ISSUE RESOLUTION STATUS REPORT

KEY TECHNICAL ISSUE: CONTAINER LIFE AND SOURCE TERM

Division of Waste Management
Office of Nuclear Material Safety and Safeguards
U.S. Nuclear Regulatory Commission

Revision 2

Figure 6. Effect of chloride concentration on repassivation potential of three different CRAs

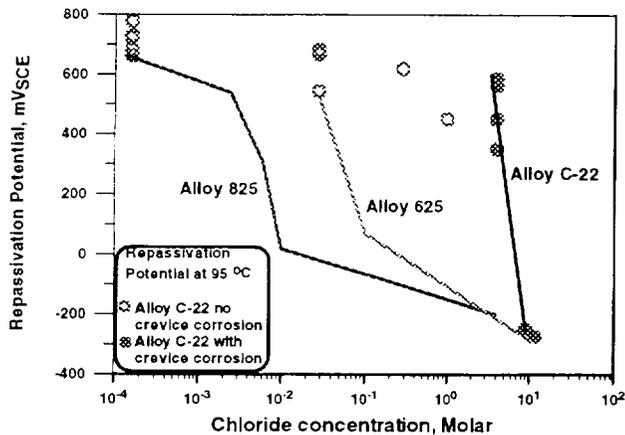
- (3) The critical temperature for localized corrosion is assumed in the TSPA-VA to be independent of chloride concentration or corrosion potential. As shown in Figure 6, the critical temperature is dependent on both chloride concentration and potential.
